E8364C-02A

S E R V I C E N O T E

E8364C PNA Microwave Network Analyzers

A new touchscreen display inverter shield is available to improve PNA noise floor performance.

Figure 1

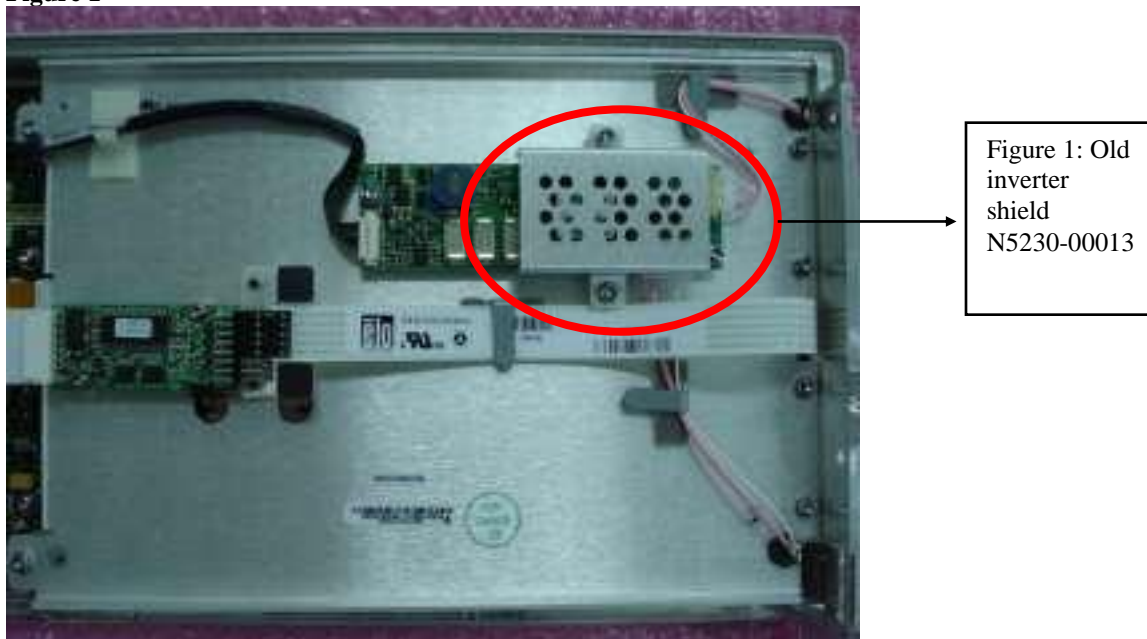
Some PNA C-models may exhibit poor noise floor performance caused by inverter shield N5230-00013.

If a PNA C-model exhibits poor noise performance, examine the inverter shield to see if it is the N5230-00013. Figure 1 shows that the N5230-00013 shield has vent holes. If present, replace the old shield (N5230-00013) with the new shield (N5230-00017) as per the following instructions.

7. Follow the instructions in the subsection "Removal Procedure."
8. Once the front panel has been removed from the PNA, place it on a flat surface. Figure 1 shows that the N5230-00013 inverter shield has vent holes.

Figure 2

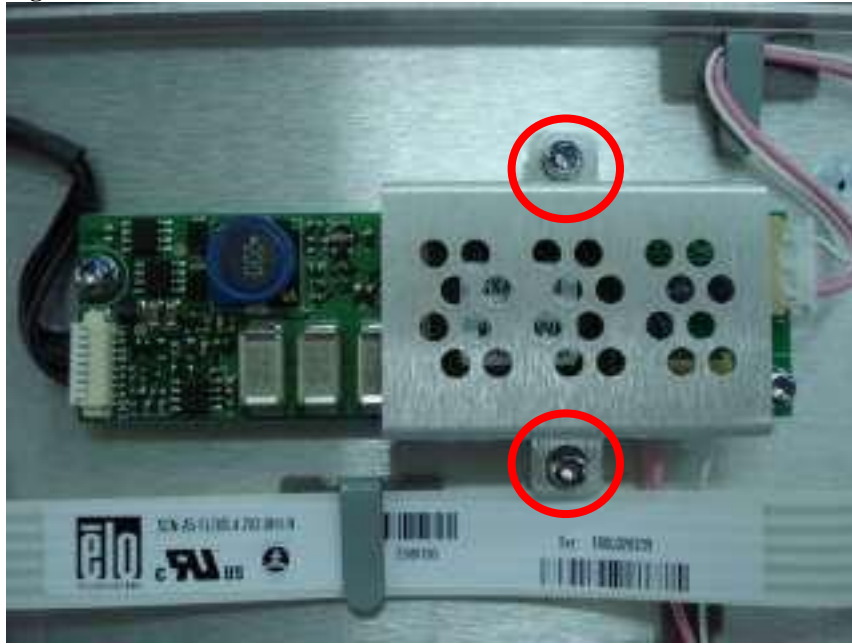
9. Loosen the two screws on the inverter shield shown in Figure 2, using a T-10 wrench.

Figure 3

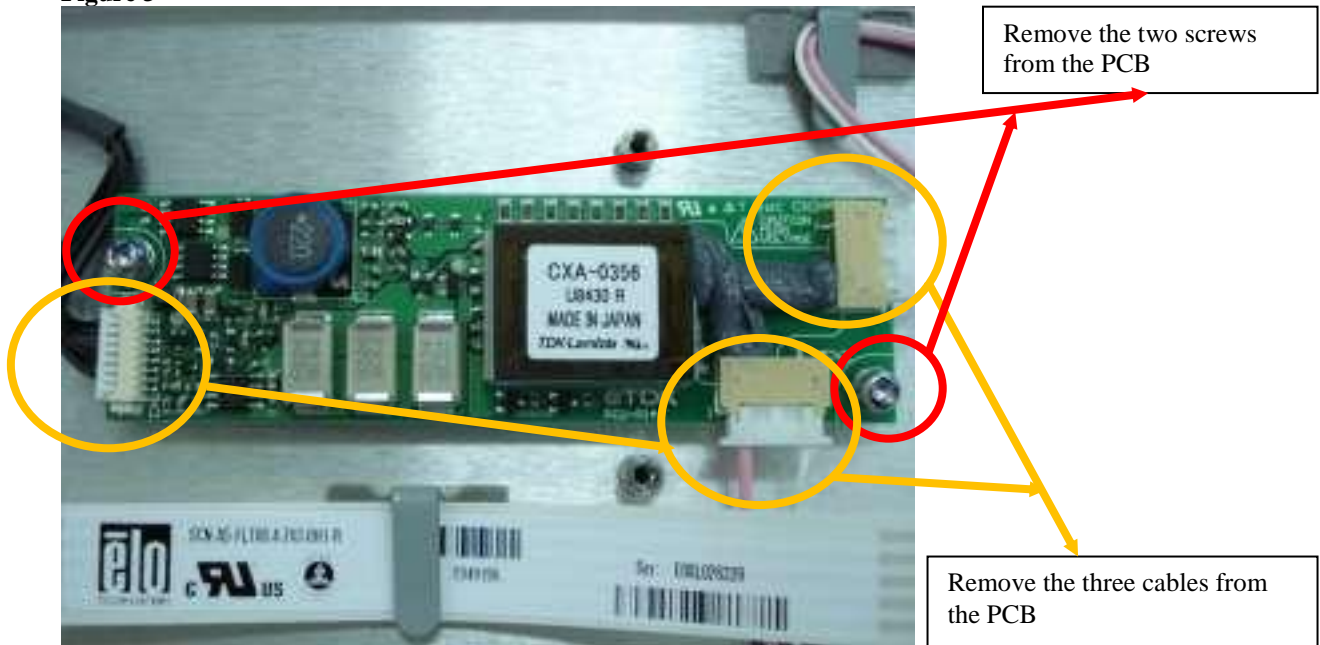
10. Remove the two screws from the PCB shown in Figure 3, using a T-10 wrench.
Disconnect the three cables connected to the PCB.
